CROSSROADS MIXED USE FILING NO. 1

CONSTRUCTION PLANS

DECEMBER 2021

EL PASO COUNTY FILE NO. SF 21-029

**STORM 3
 STA 1+00.00 TO STA 1+92.26
 (PUBLIC)**

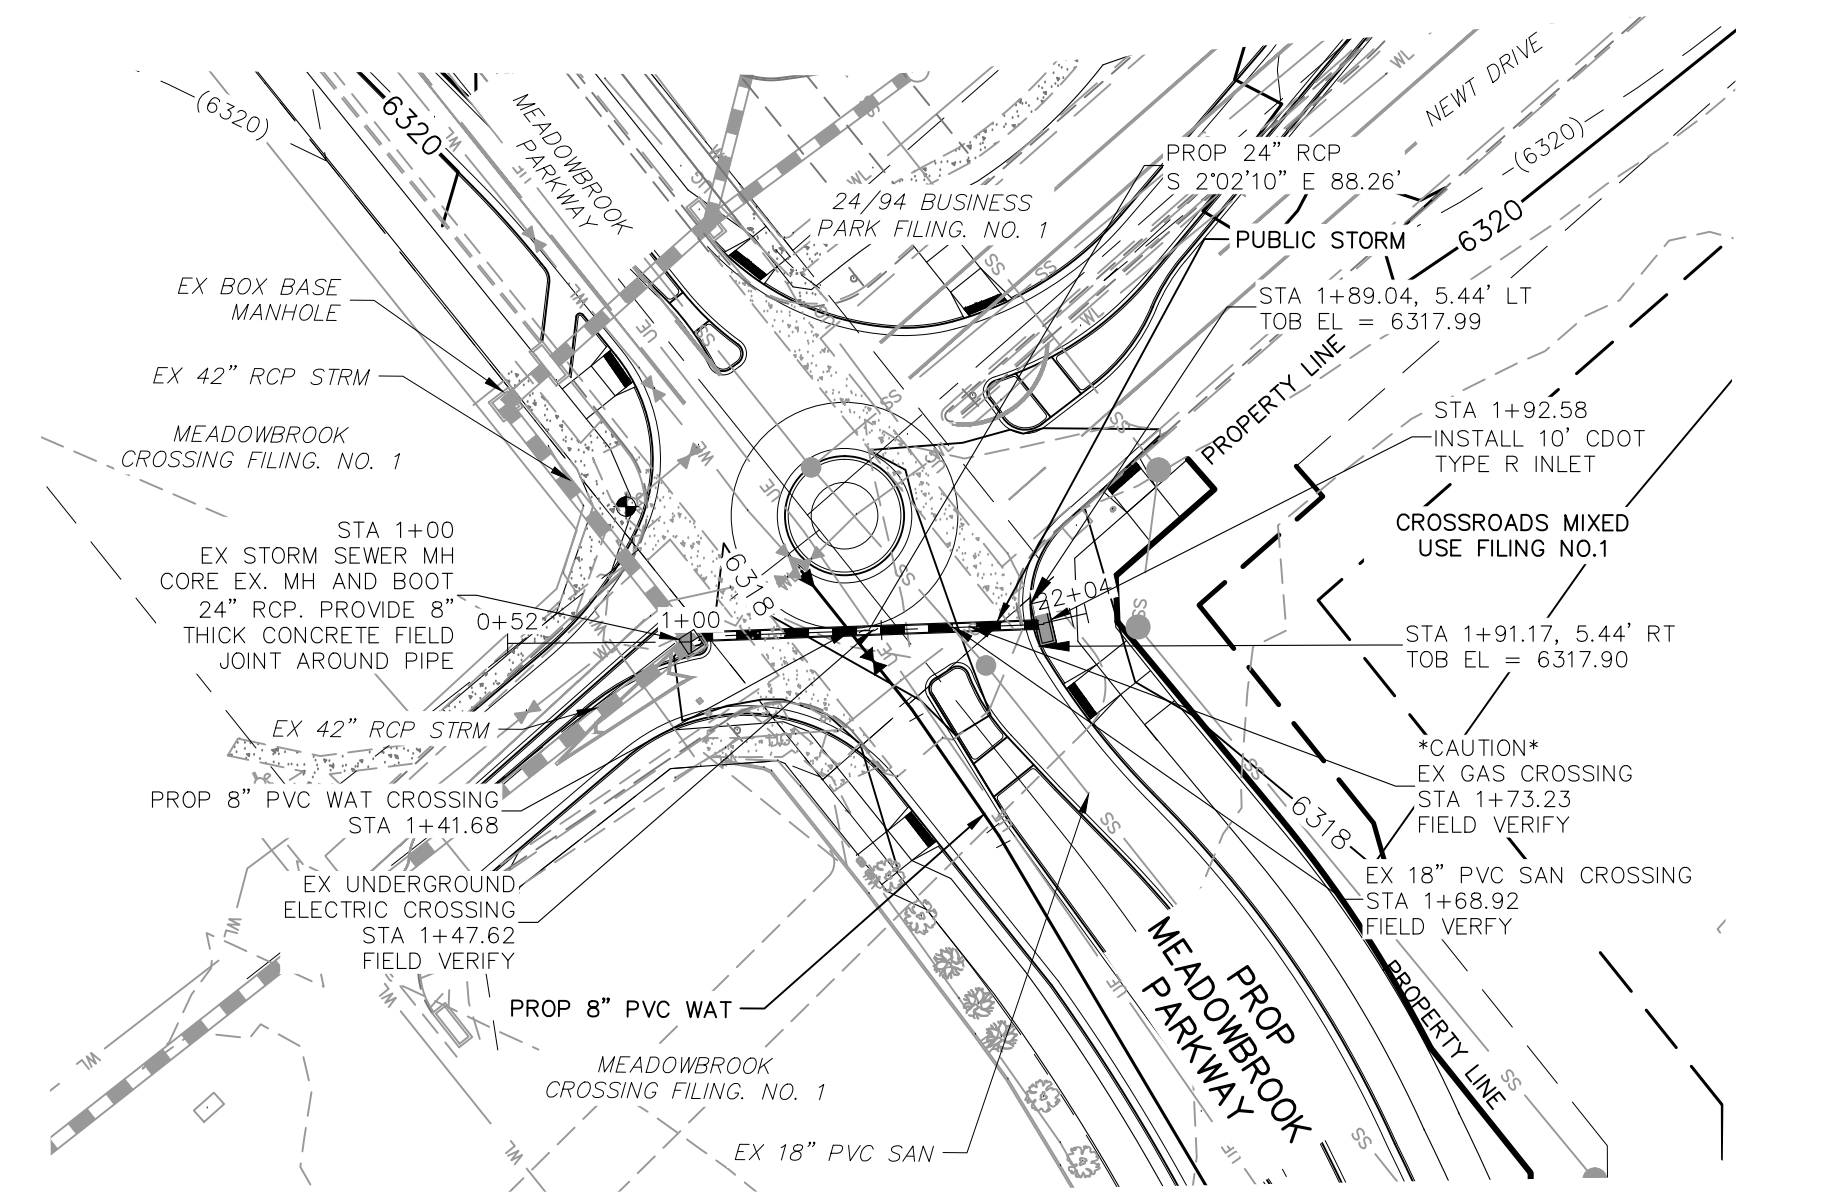
Adjust storm layout. The current manhole location will conflict with the future C&G/extension of Meadowbrook Parkway.

Water crossing does not match what is shown on utility plans

Pipe cannot switch between private and public in the middle of a pipe run. Please adjust to change from private to public at left side of the inlet.

Does not match what is shown on utility plans

Water crossing does not match what is shown on utility plans

STORM 4 (PRIVATE)
STA 1+00.00 TO STA 4+52.47

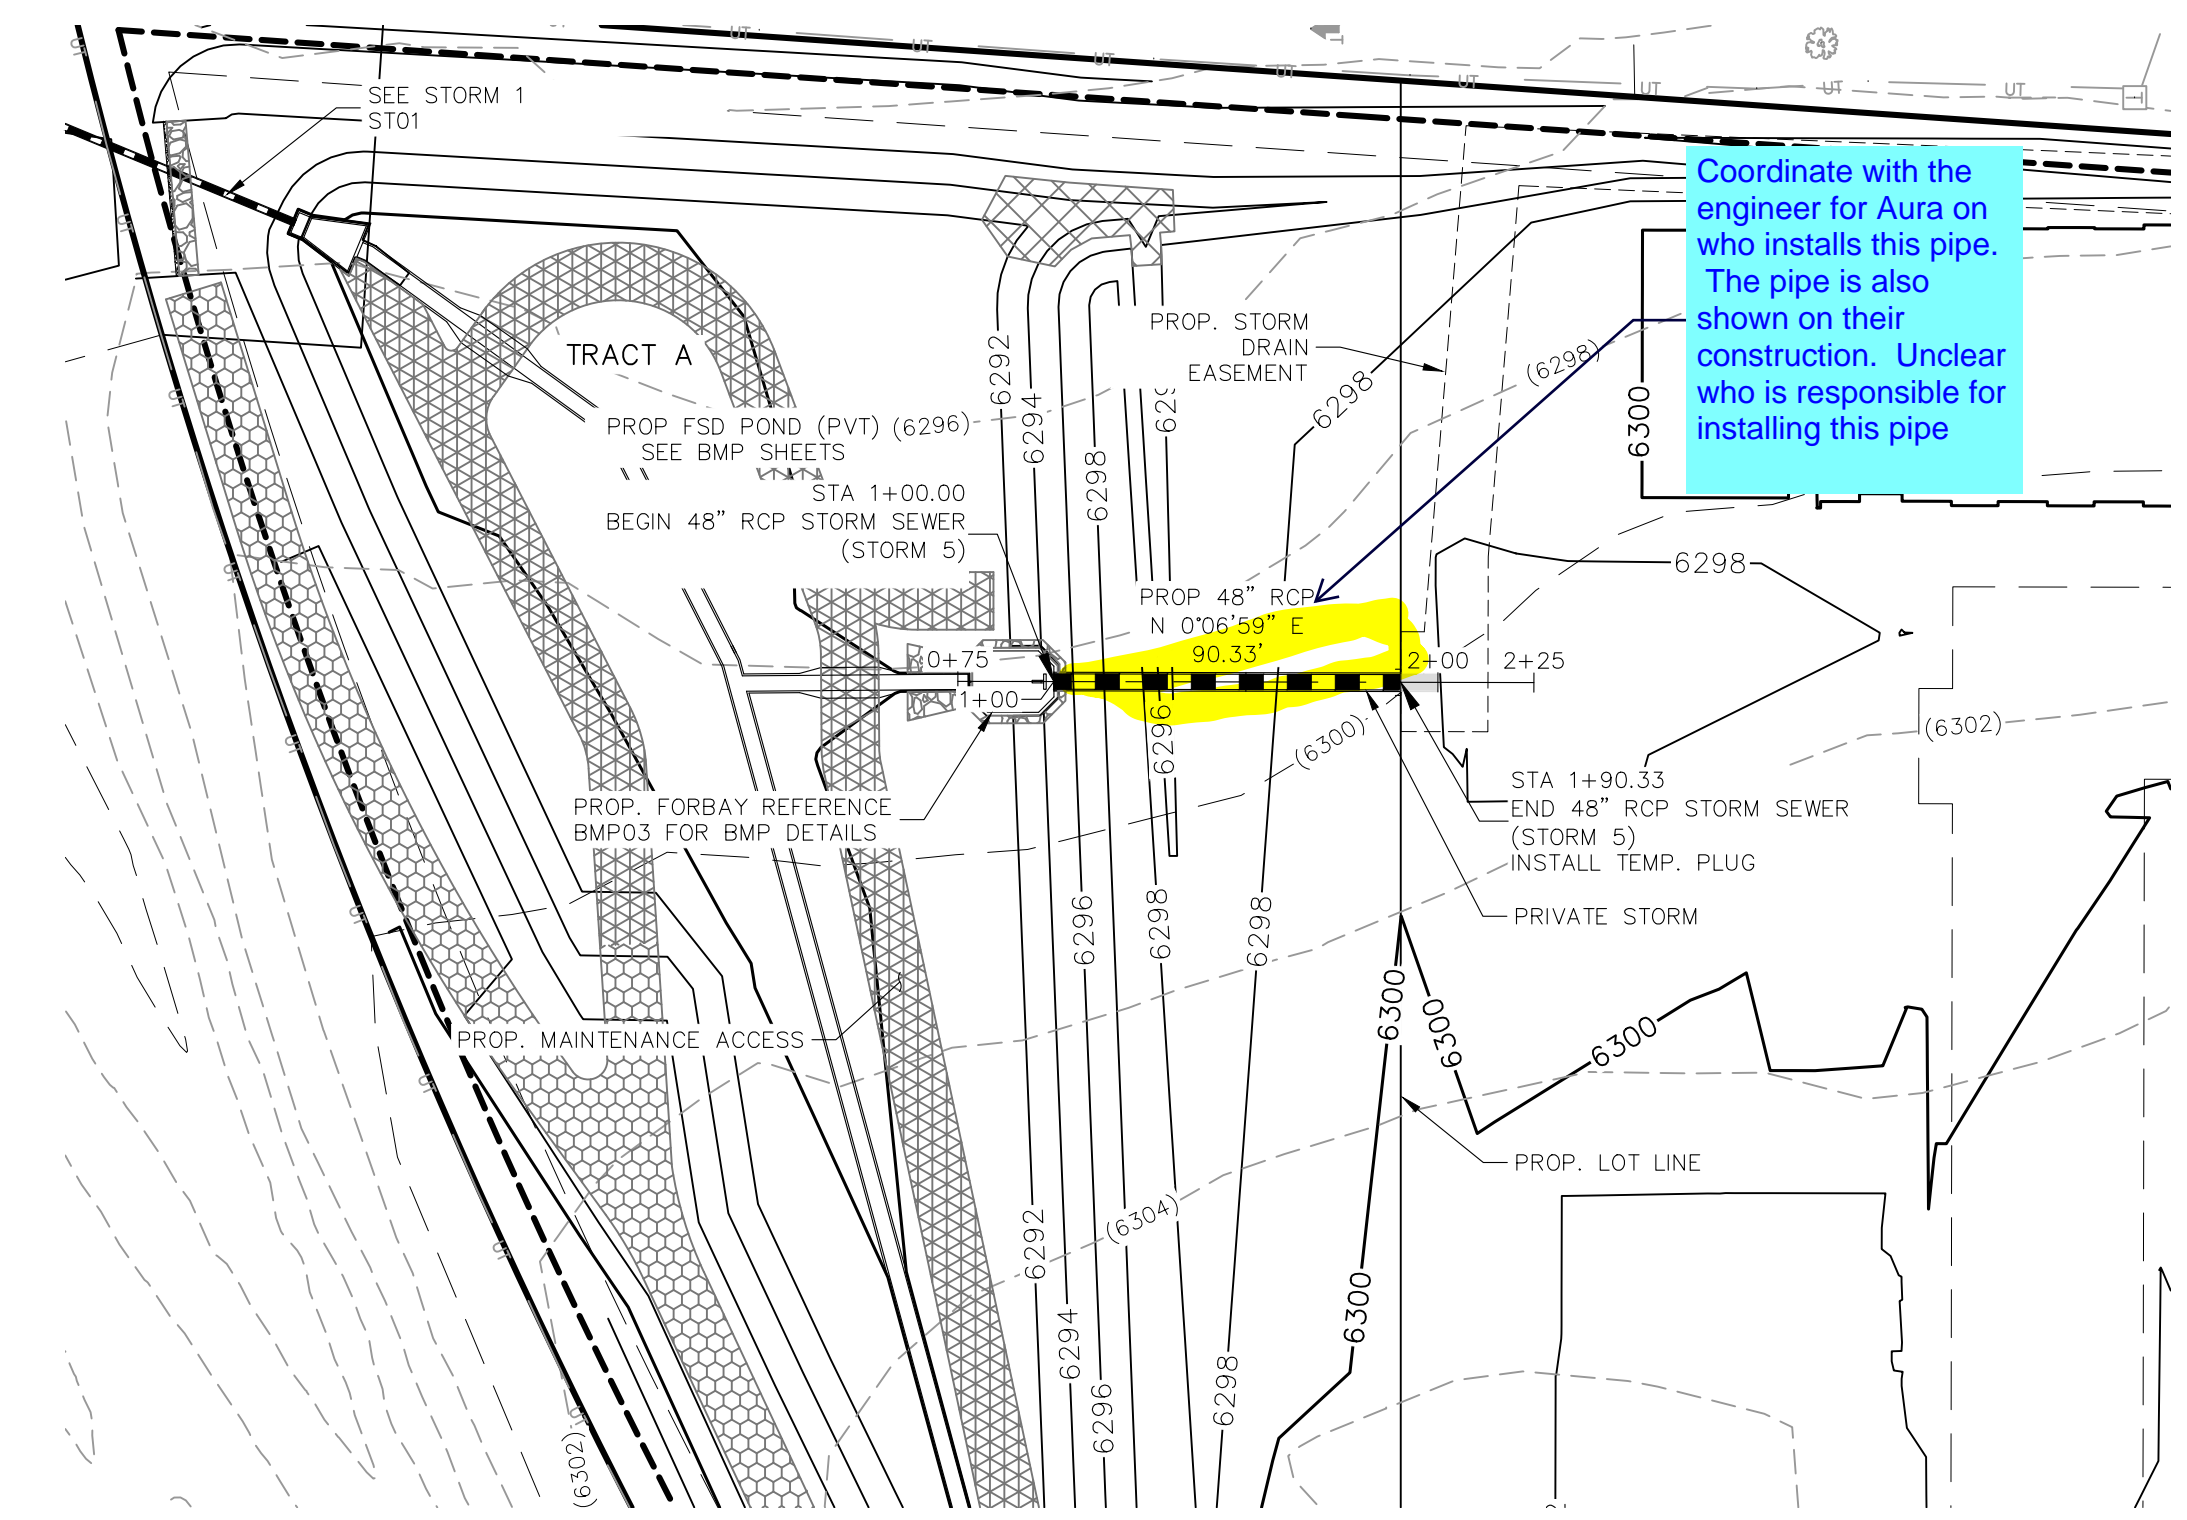
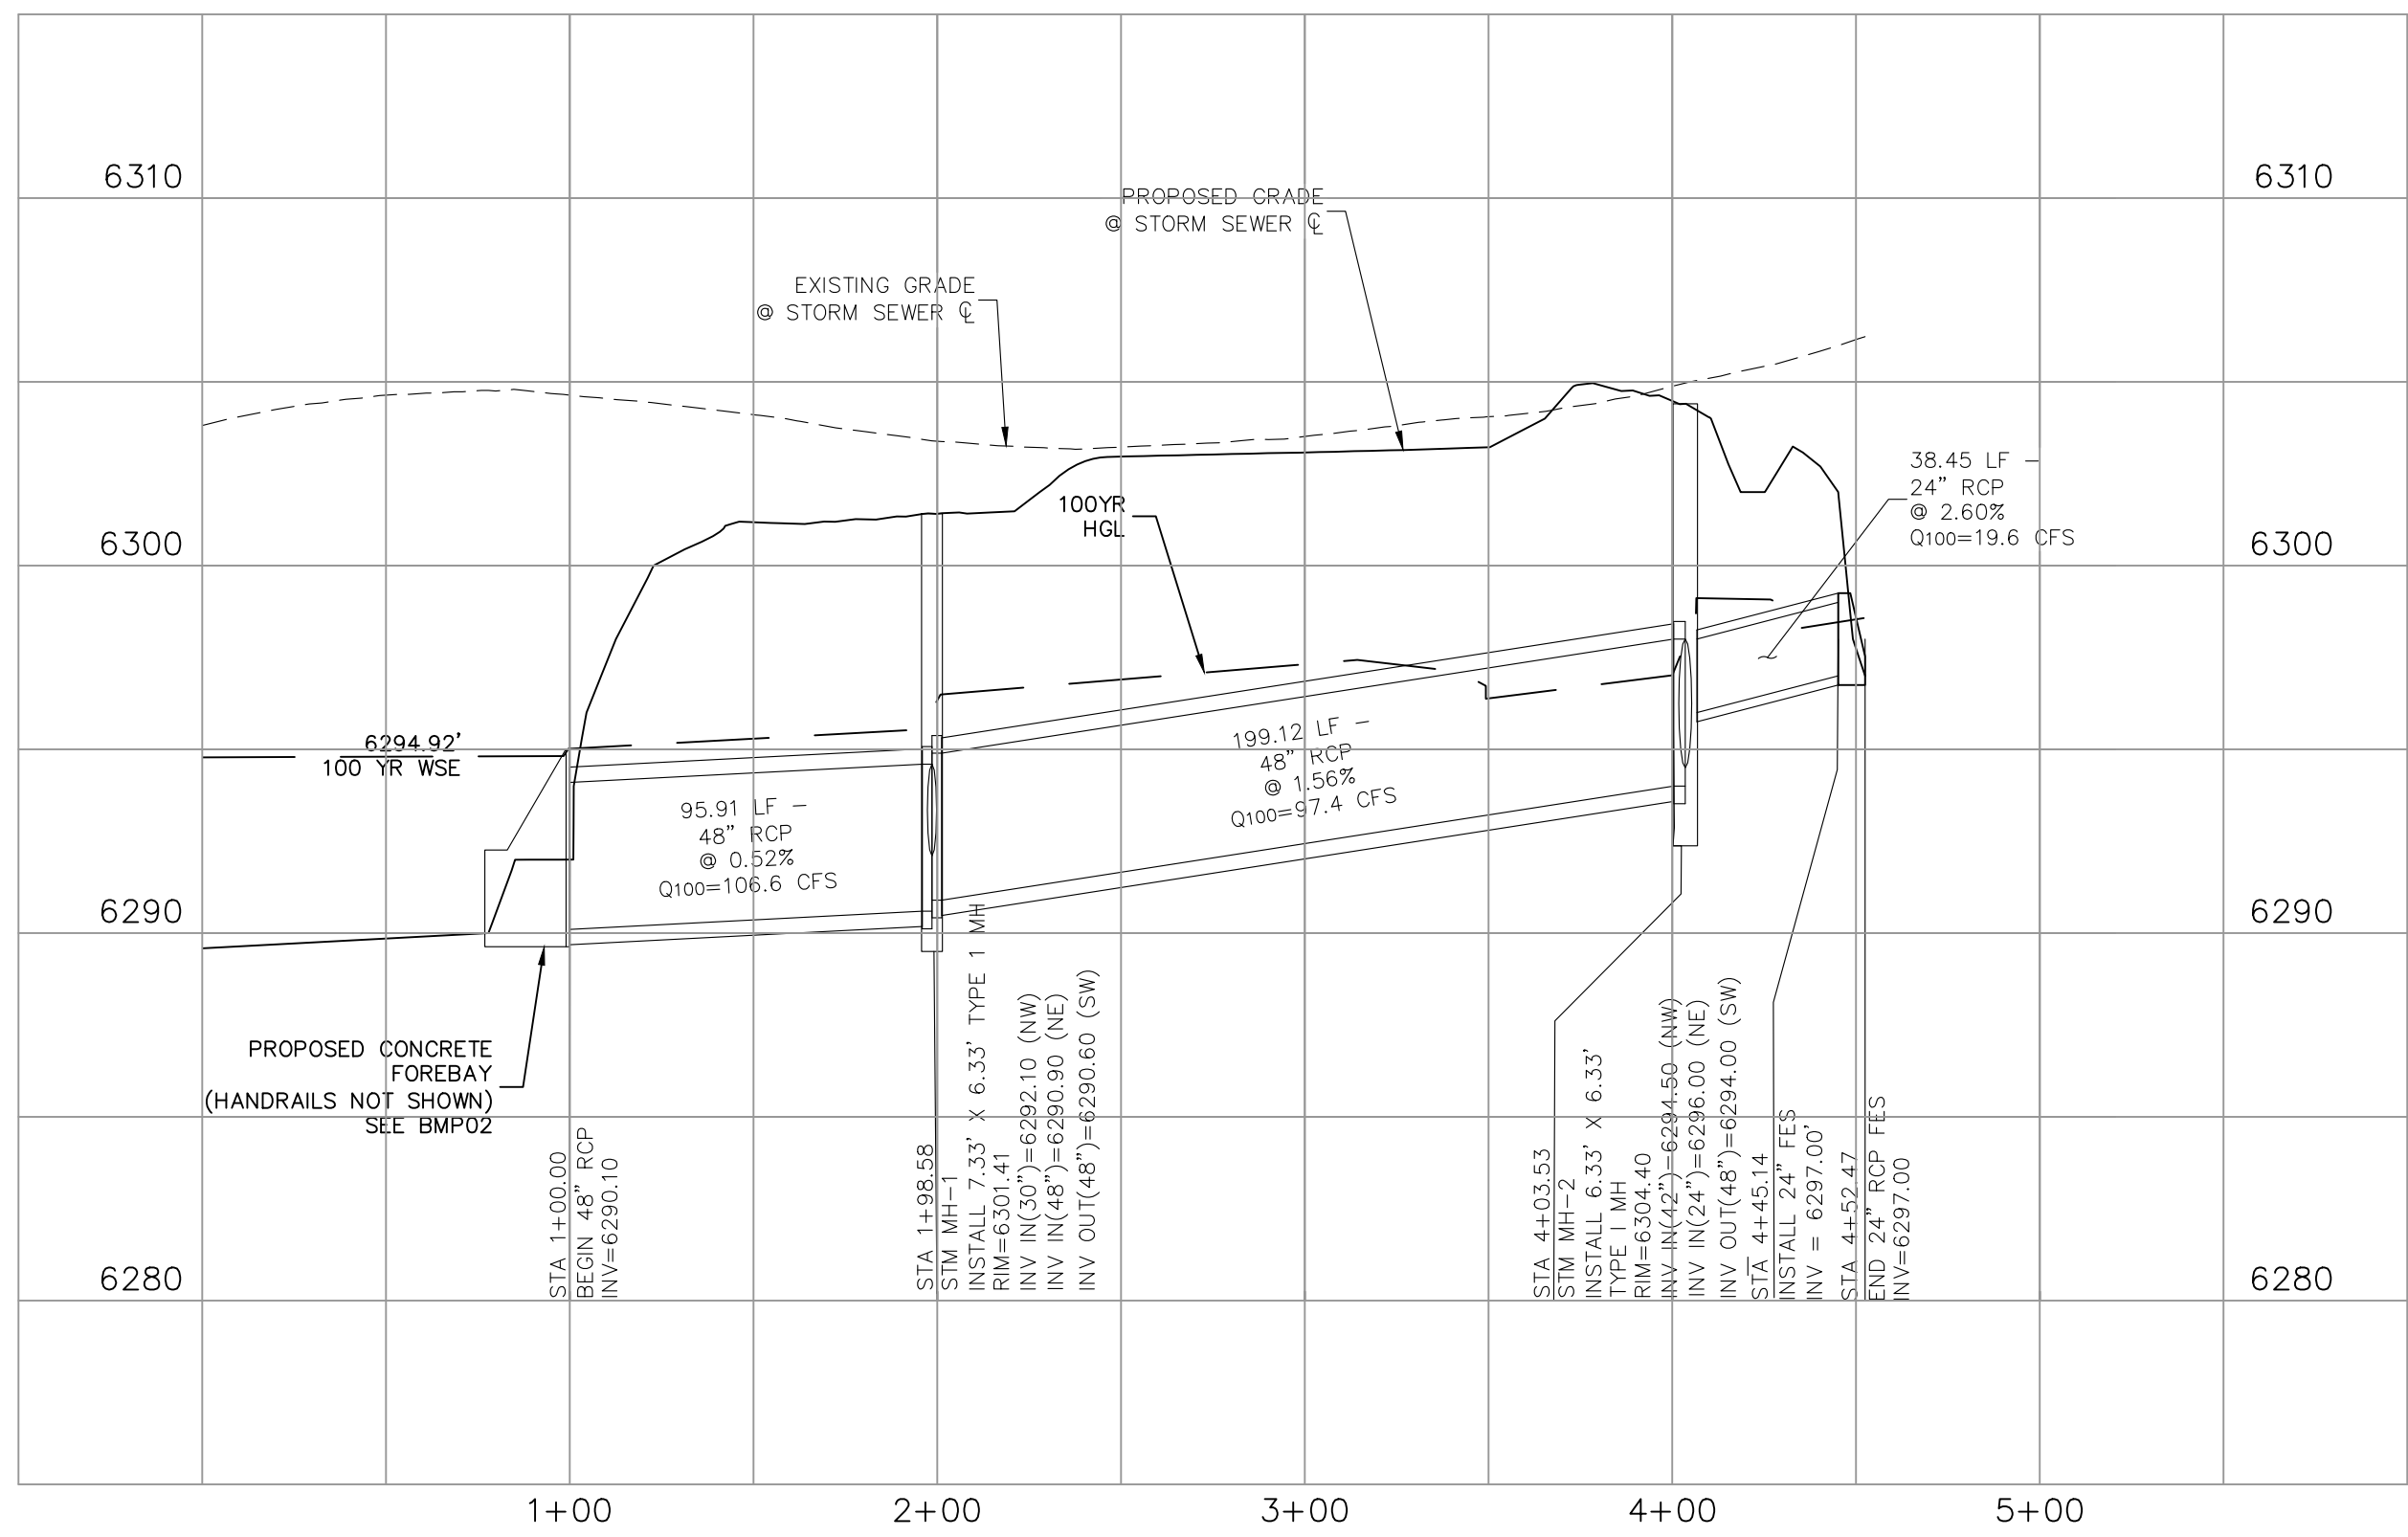
Coordinate with the engineer for Aura on who installs this pipe. The pipe is also shown on their construction. Unclear who is responsible for installing this pipe

This system was not included in FDR calculations. Please add to report.
